Draft Architectural Guidelines
Community Feedback
Updated on March 11, 2023

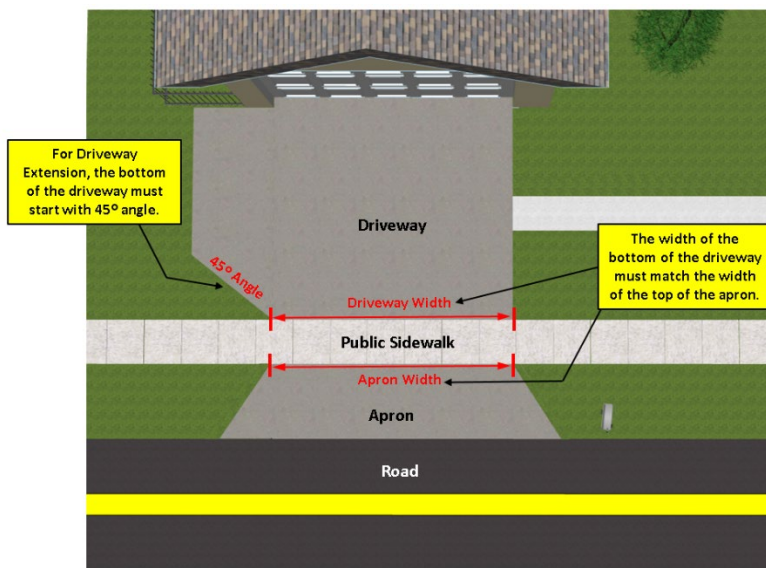
1. I'm not a fan of the updates to the Driveway section of the ARC Guidelines. When I bought my house in 2020 one of the reasons, I liked the lot is that I can park both my wife and my car in the driveway without blocking one of us in. The proposed updates would suggest that our driveway is not in compliance because all of it does not line up with the sidewalk. I understand that I would be grandfathered in, but the way that the document is written today is that in 20-30 years when I replace my driveway again, I'd have to substantially shrink the size to match the sidewalk footprint, which I do not want to do. I do not plan on selling my house, so I am concerned about the long term here.

1. The driveway may be up to 18 feet wide but the bottom width must match the width of the apron (see picture below – note 45 degrees is the maximum angle). The guidelines will be updated to clarify this point.
